# LIFE SAFETY & STRUCTURAL CHECKSHEET

16-187454-000-00-RS

**4711 N CONGRESS AVE**

UNIT 2 OF 2-UNIT TOWNHOUSE on individual tax lot 2-STORY/ATTACHED GARAGE/FLAT

11 SEISMIC TIE BETWEEN BUILDINGS

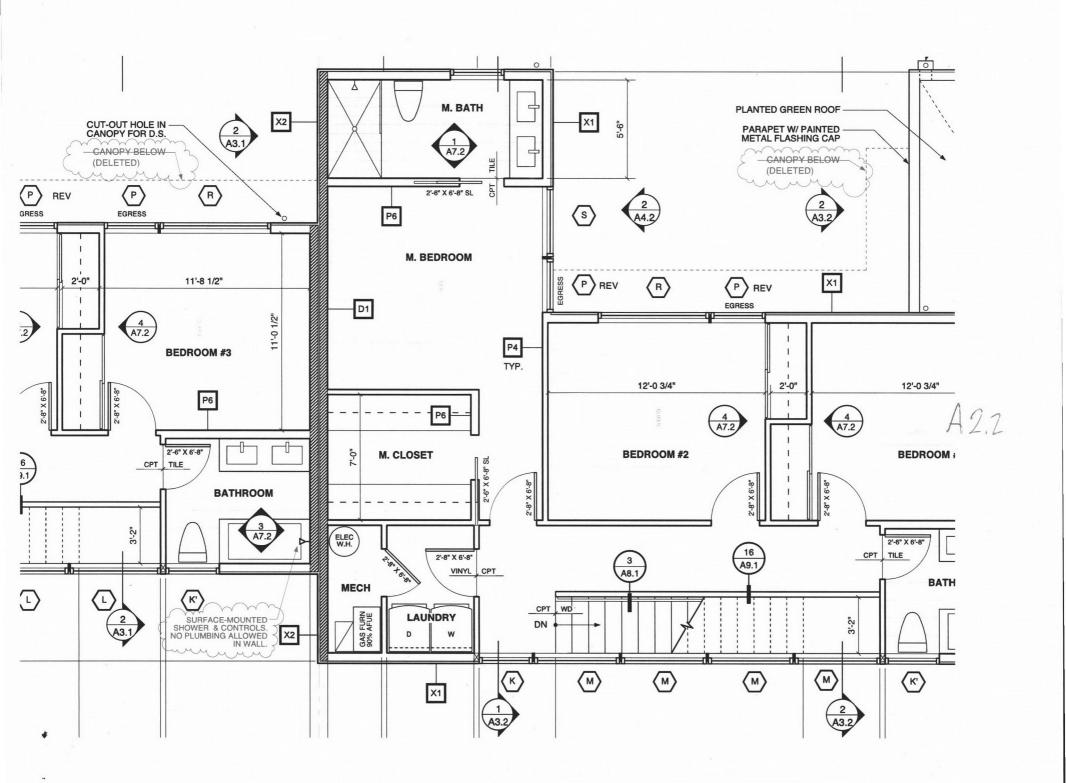
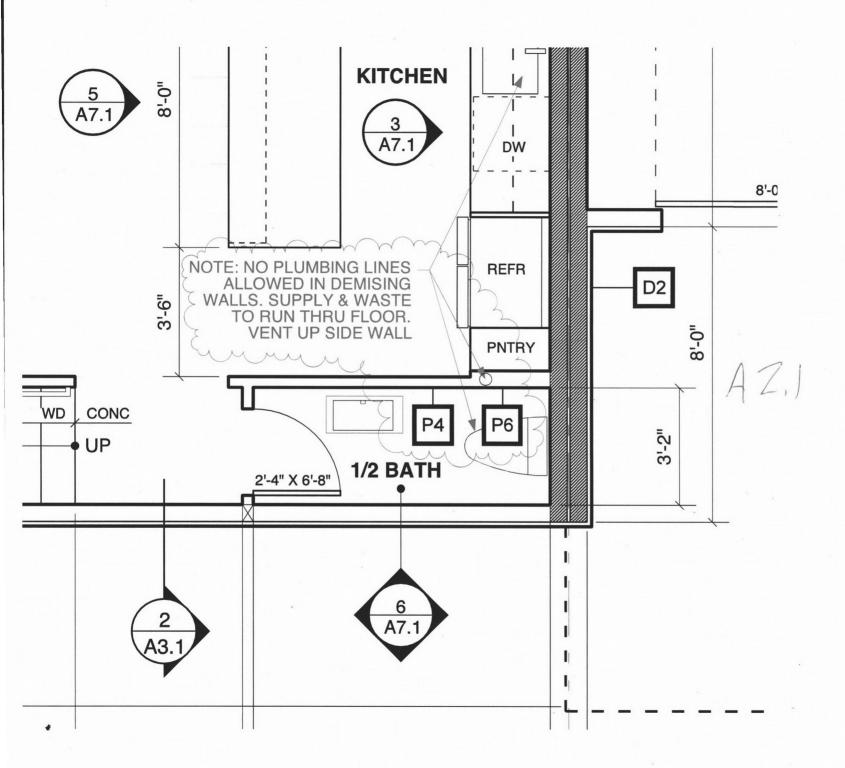
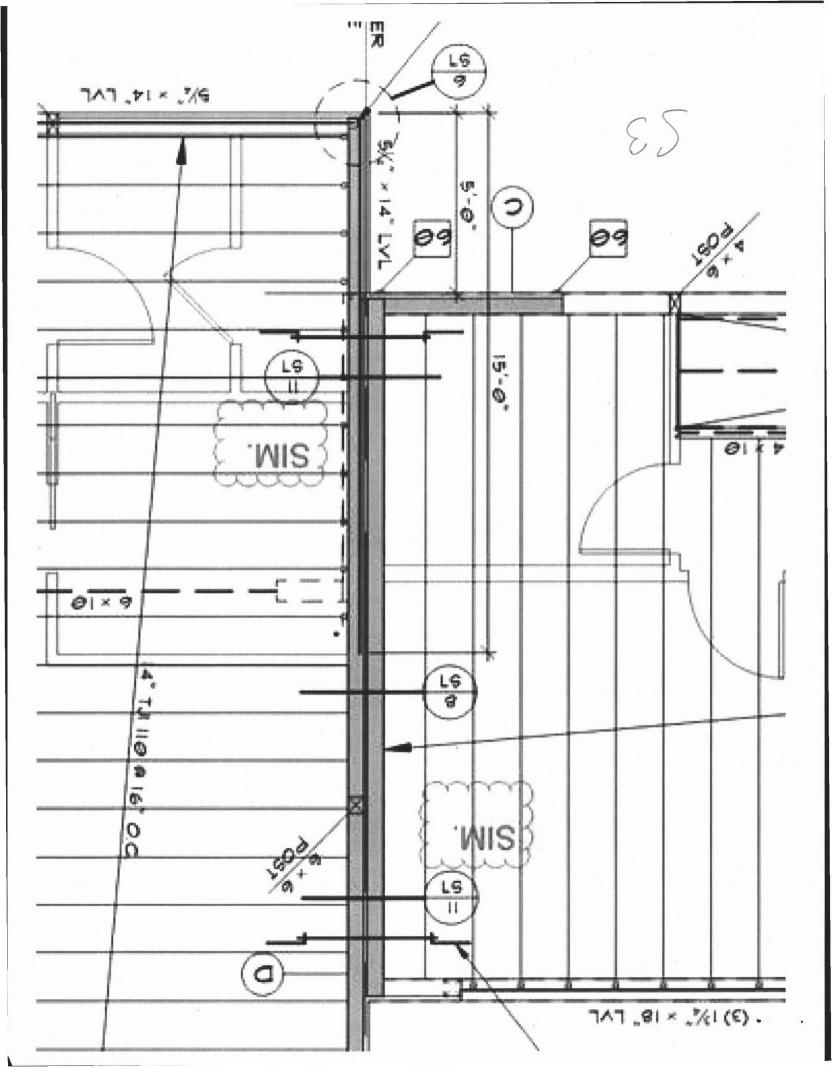
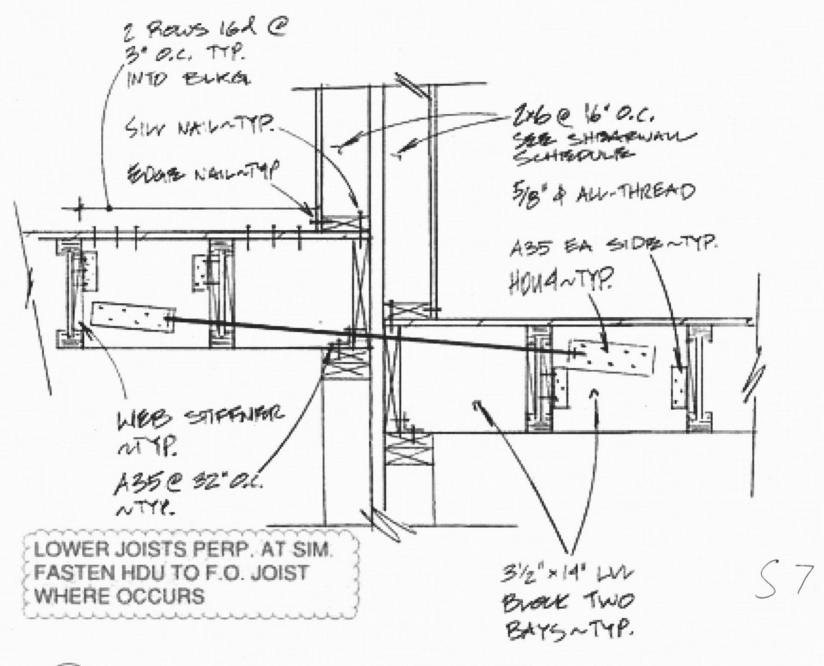
Residential Specialty Code and/or other City requirements.				
Item #	Location on plans	Code Section	Clarification / Correction Required	
1	Attach- ment	R302.2.1.1.1	Edit the attached Maintenance Agreement to reflect the properties for permits #16-187454 & #16-187445. You may return the draft via email to me for review. Do not sign/notarize the document until I have reviewed and accepted the draft. A signed copy of the draft will then be available to you at the 5 <sup>th</sup> floor reception at which point you will notarize, and then email the notarized copy back to me to be recorded and on file for these properties.	
2	A2.1 A2.2	R302.2 (2)	Plumbing and mechanical ducts/vents are not permitted in a "modified" 2-hour fire-resistance rated firewall at the property line is not permitted. Either fir the walls to accommodate the plumbing at both the Bathrooms & Kitchen in Unit 2, or reconfigure the Bathrooms and Kitchen to avoid penetration.

3	A2.1	R302.2.7.2	(3) There is not an adjacent cantilever in Unit 2, therefore 1-3 of this code requires fire-resistive-rated walls to be continuous from the foundation to the roof sheathing. Extend the wall from above to an approved footing below, or provide a fire suppression system in accordance with NFPA 13D.	
4	S7	R106.1.1	The orientation of floor joists on S3 in Unit 1 does not match the detail in regard to the floor joist direction for attachment of the seismic tie between the two units. See detail 8 for correct orientation.

Description of changes, corrections, additions, etc. BY OTHER  CORRECT, AS NOTED IN THE WALL TYPES SHEET A0.1. IN THE LOCATIONS MENTIONED, PLUMBING SUPPLY & WASTE LINES ARE TO RUN UP FROM THE FLOOR AND VENT LINES TO BE IN THE SIDEWALLS. ADDITIONAL NOTES HAVE BEEN ADDED TO THE PLANS NOTING THAT.	ATTACHMENT A0.1, A2.1, A2.2
IN THE LOCATIONS MENTIONED, PLUMBING SUPPLY & WASTE LINES ARE TO RUN UP FROM THE FLOOR AND VENT LINES TO BE IN THE SIDEWALLS. ADDITIONAL NOTES HAVE BEEN	A0.1, A2.1, A2.2
R302.2.7.2 ITEM #3 ALLOWS FOR CANTILEVERED LIVING AREA WITHOUT AN ADJACENT CANTILEVER PROVIDED A 1-HOUR WALL EXTEND TO THE FURTHEST POINT OF THE CANTILEVER. THAT IS THE CASE, AS DESIGNED.	A2.1, A2.2
A PLAN NOTE HAS BEEN ADDED TO THE TWO DETAIL CUTS 11/S7 WHICH OCCUR ON S3 TO INDICATE A SIM. CONDITION. A NOTE HAS ALSO BEEN ADDED TO DETAIL 11/S7 TO INDICATE THAT JOISTS ARE PERPENDICULAR AT SIM. AND THAT THE HDU HOLDOWN SHOULD BE NAILED TO THE FACE OF JOISTS.	S3 AND S7

n e e e	WEM
	La transfer
2 1 1 1 2 5	2016
809	
DOCUMENT.	SERVICES
1	WITHOUT AN ADJACENT CANTILEVER PROVIDED A 1-HOUR WALL EXTEND TO THE FURTHEST POINT OF THE CANTILEVER. THAT IS THE CASE, AS DESIGNED.  A PLAN NOTE HAS BEEN ADDED TO THE TWO DETAIL CUTS 11/S7 WHICH OCCUR ON S3 TO INDICATE A SIM. CONDITION. A NOTE HAS ALSO BEEN ADDED TO DETAIL 11/S7 TO INDICATE THAT JOISTS ARE PERPENDICULAR AT SIM. AND THAT THE HDU HOLDOWN SHOULD BE NAILED TO THE FACE OF JOISTS.
